Project: ELON HAWK RIDGE POLO RELIEF ES

Submittal No. / Revision: 237412-1 1 Subcontractor/Supplier: Superior Mechanical Systems (Charlotte)	Description: Single Zone Packaged Rooftop Units - Product Data
Submittal Type: Product Data Spec. Section & Paragraph No.: 237412	Required on site by: Required lead time: Status: Submitted to AE
Notes: A. Product Data: Include manufacturer's technical data for each RTU, including rated capacities, dimensions, required clearances, characteristics, furnished specialties, and accessories.

In accordance with Specification SECTION 237412
SINGLE ZONE PACKAGED ROOFTOP UNITS

CONNECTION SIZES	
E	3/4"-14 NPT CONDENSATE DRAIN

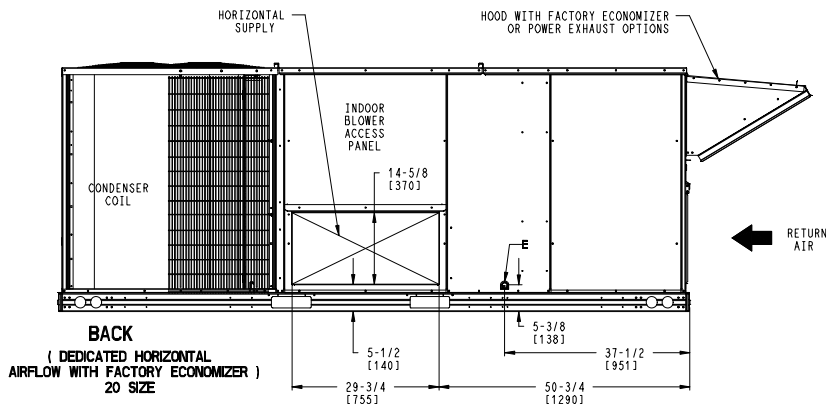
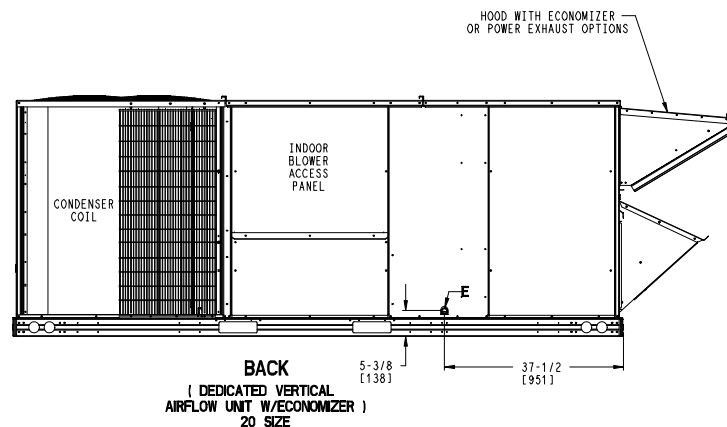
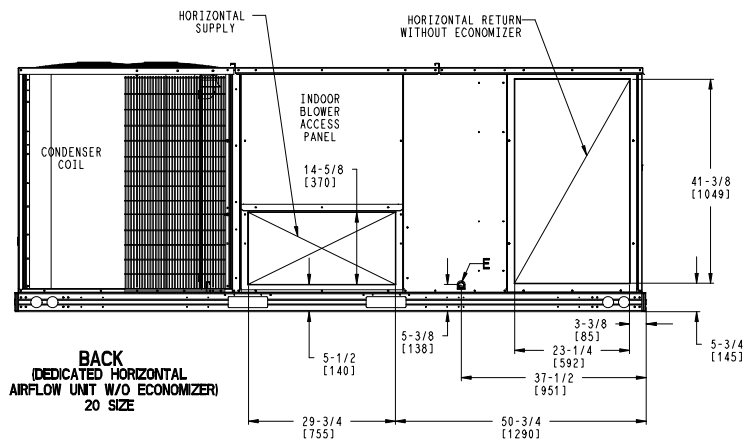
Schedule calls for stainless
steel drain pan

Schedule calls for stainless steel drain pan
